STAFF REPORT

Review of Los Angeles Department of Water and Power 2023 Integrated Resource Plan

April 2025 | CEC-200-2025-010

Figure 3: LADWP's Total Net Energy for Load and Forecasted Peak Demand

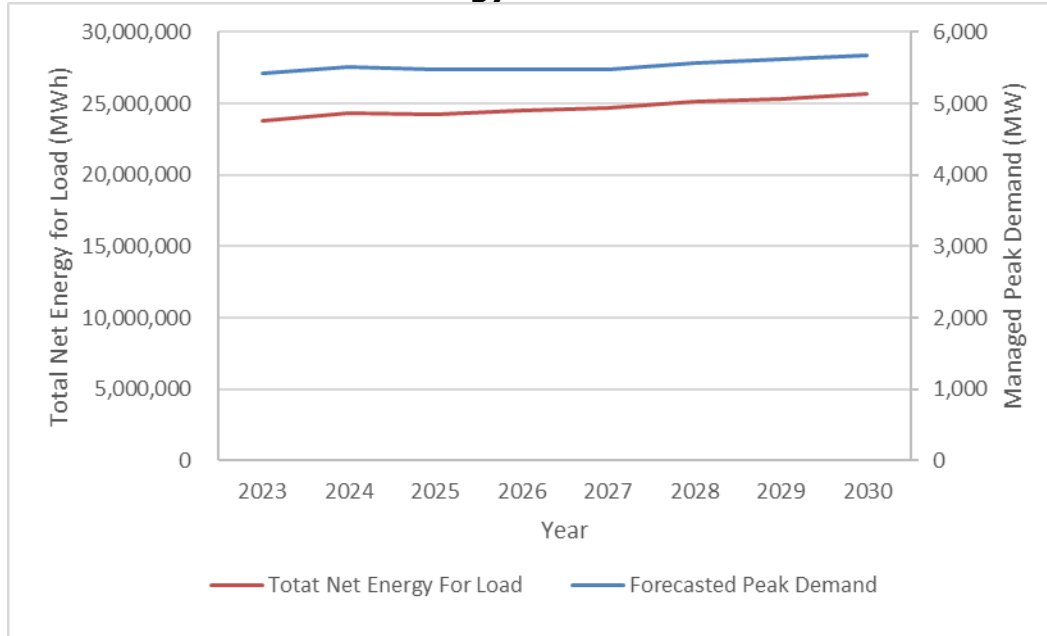
Staff compared LADWP's forecasted peak demand and total net energy for load to the CEC's California Energy Demand 2023-2040 Baseline Forecast.⁹ LADWP's forecasted peak demand is below the CEC's 1-in-2 peak demand through 2029, and between the 1-in-2 and 1-in-5 peak thereafter. This comparison does not include the substantial quantity of reserve capacity procured by LADWP. LADWP's total net energy for load is nearly the same as the CEC's forecast for managed retail sales to end use customers, roughly 0.1 percent larger over every year of the forecast period.
